Title - Sujet Roof Replacement	
Solicitation No. - N° de l'invitation EP076-150970/A	Amendment No. - N° modif. 001
Client Reference No. - N° de référence du client 20150970	Date 2014-10-23
GETS Reference No. - N° de référence de SEAG PW-\$\$\$FG-353-65832	
File No. - N° de dossier fg353.EP076-150970	CCC No./N° CCC - FMS No./N° VME
Solicitation Closes - L'invitation prend fin at - à 02:00 PM on - le 2014-10-28	Time Zone Fuseau horaire Eastern Daylight Saving Time EDT
F.O.B. - F.A.B. Plant-Usine: <input type="checkbox"/> Destination: <input checked="" type="checkbox"/> Other-Autre: <input type="checkbox"/>	
Address Enquiries to: - Adresser toutes questions à: Searchwell, Suzette	Buyer Id - Id de l'acheteur fg353
Telephone No. - N° de téléphone (819) 956-6645 ()	FAX No. - N° de FAX (819) 956-8335
Destination - of Goods, Services, and Construction: Destination - des biens, services et construction: Building M23, NRC Campus 1200 Montreal Road Ottawa, Ontario

ADDENDUM NO. 001

The following changes in the bid documents are effective immediately. This addendum will form part of the contract documents.

NEW CONSTRUCTION ROOF PLAN

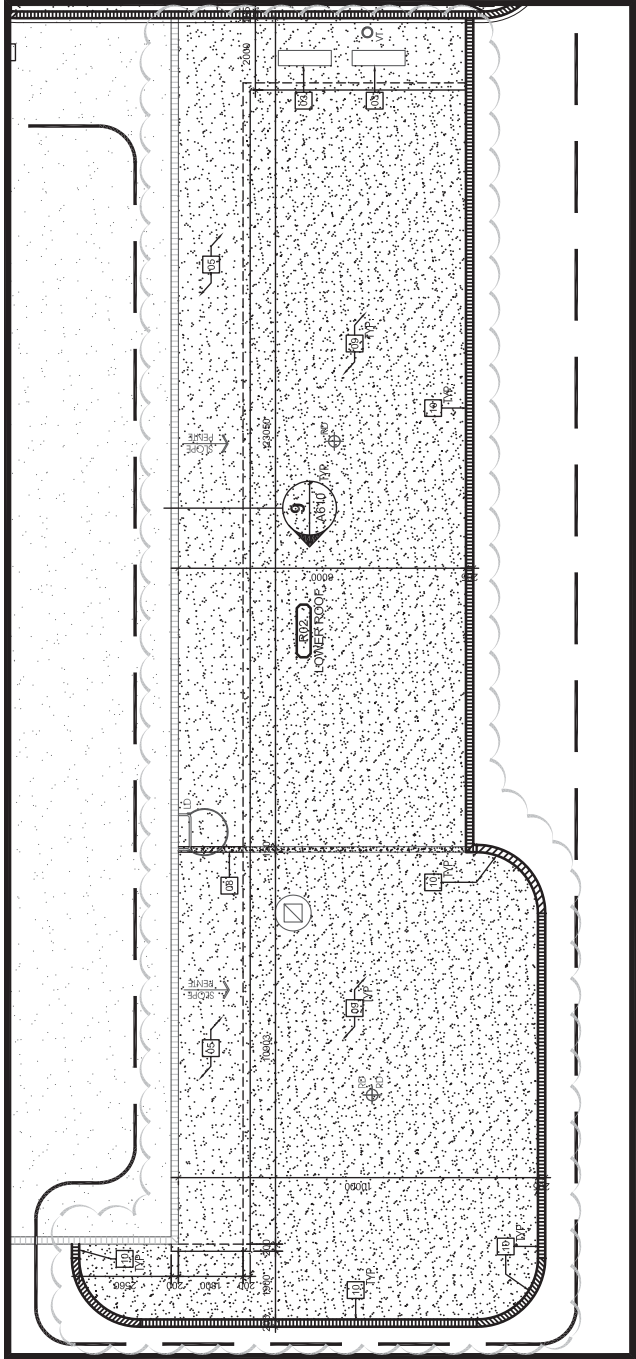
- .1 A200 – EXISTING/DEMOLITION ROOF PLAN
 - .1 **Add the following items to the scope on Lower Roof R02 as follows:**
 - .1 Remove existing parapet flashing, refer to attached sketch SK-A200.1.
- .2 A210 – NEW CONSTRUCTION ROOF PLAN
 - .1 **Add the following items to the scope on Lower Roof R02 as follows:**
 - .1 Provide new cap flashing membrane over existing roof, refer to attached sketch SK-A210.1.
 - .2 Replace flashing on the existing parapet, refer to attached sketch SK-A210.1.

- 03REINSTALLED MECHANICAL UNIT BY OTHERS, PROVIDE SLEEPERS, REFER TO DETAILS. COORDINATE WITH PHASING PLAN AND OWNER.
- 05PROVIDE NEW ROOF ASSEMBLY 'R1' TO EXTENTS SHOWN. LAP AND SEAL W/ EXISTING MEMBRANE, 400mm MIN.
- 08REINSTATE EXISTING ROOF CURB, REFER TO SIMILAR DETAIL 5/A610.
- 09PROVIDE MOD. BIT. CAP SHEET OVER EXISTING ROOF MEMBRANE THROUGHOUT ROOF R02. INSTALL THE NEW CAP SHEET ONCE THE REPAIRS ALONG THE WALL ARE COMPLETED.
- 10PROVIDE NEW PRE-FINISHED COUNTER FLASHING OVER EXISTING PARAPET, CLIPPED AND SEALED.
